30-039-30158 SAN JUAN 30 4 UNIT #105

Southland Royalty Company LLC requests approval to plug and abandon the San Juan 30-4 Unit #105.
Attached are the Proposed Procedure, WBDs, and Reclamation Plan.

CONDITIONS OF APPROVAL

BLM FLUID MINERALS Geologic Report

PROPOSED P&A

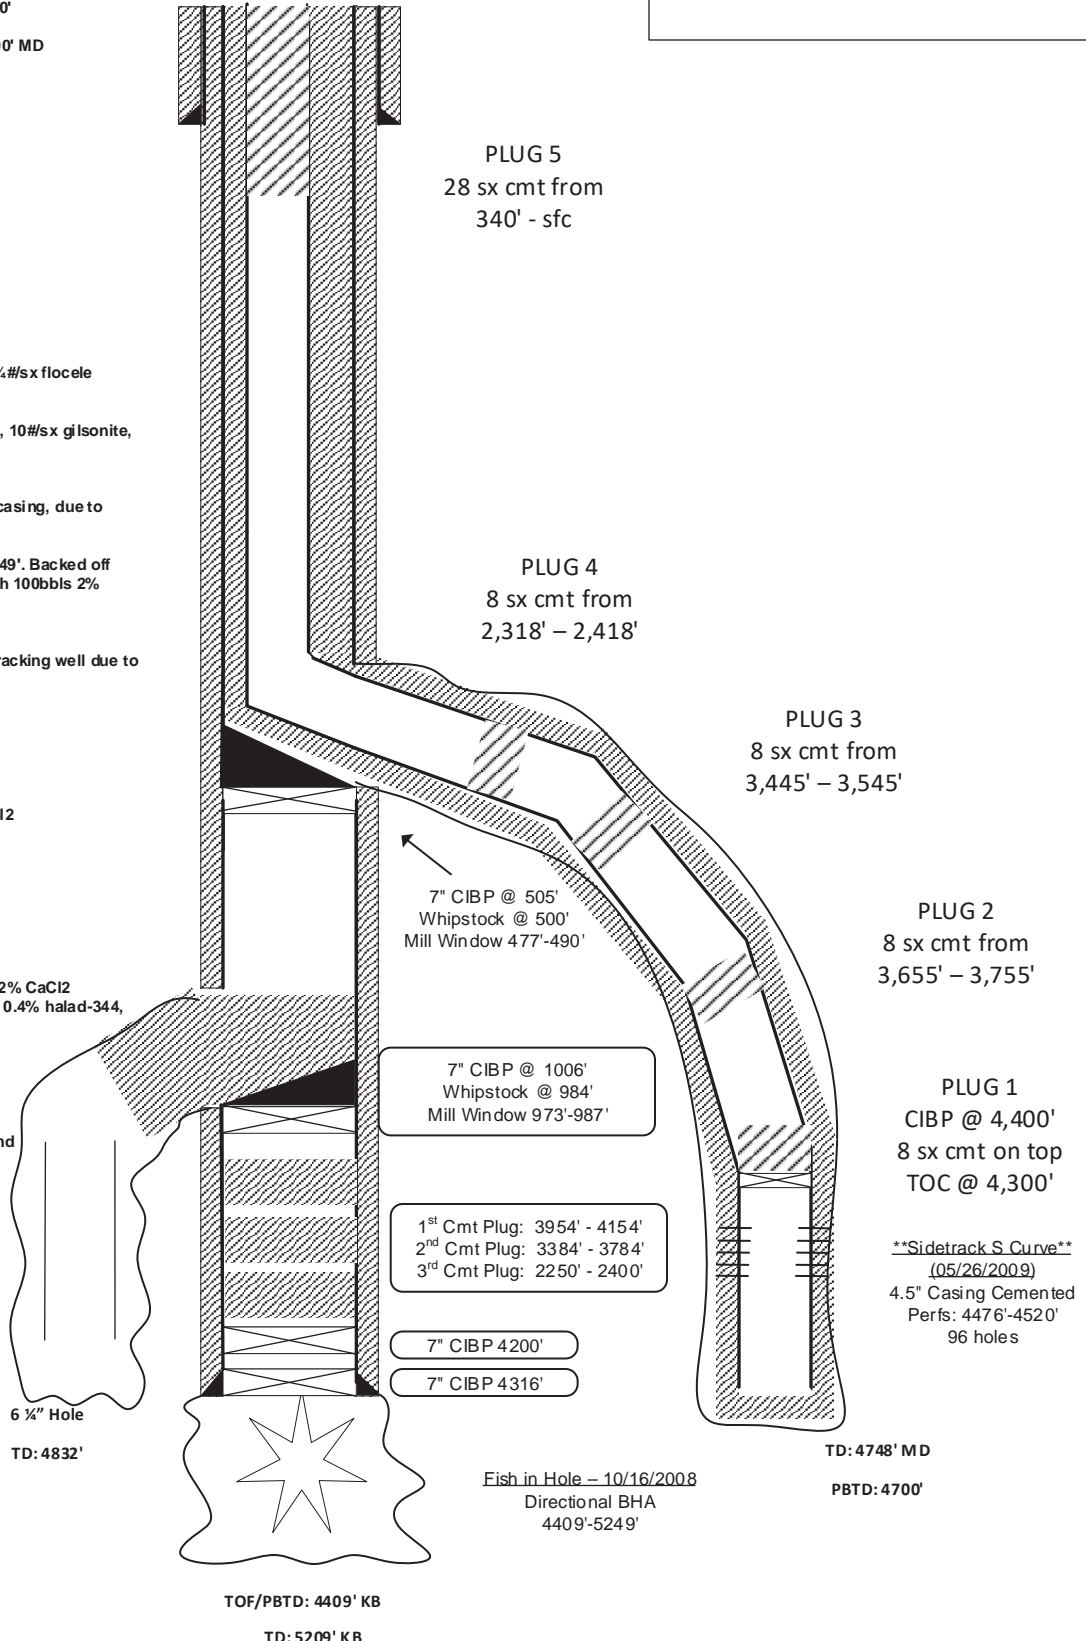
- Notify NMOCD 24 Hours prior to commencing activities
- In addition to BLM-approved plugs
 - Include a plug 4190'-4090.' OCD P.C. pick @ 4140.'
 - Include a plug 4062'-3962.' OCD Fruitland pick @ 4012.'
 - Include plug 3570'-3925.' OCD Kirtland pick @ 3875,' Ojo Alamo pick @ 3620.'
 - Include plug 2555'-2445.' OCD Nacimiento pick @ 2505.'

- The subject well is a non-vertical sidetrack. The P&A procedure lacks any submitted formation top depths, either in measured (MD) or true vertical depth (TVD). The depths listed in the schematic diagram are a mixture of measured depths and true vertical depths. The formation tops in this report are TVD and the operator must ensure that the plugs are placed at the correct vertical depths.

- Please ensure that the tops of the Pictured Cliffs, Fruitland, and Nacimiento formations as well as the entire Ojo Alamo aquifer, identified in this report, are isolated by proper placement of cement plugs. This will protect the freshwater sands in this well bore.
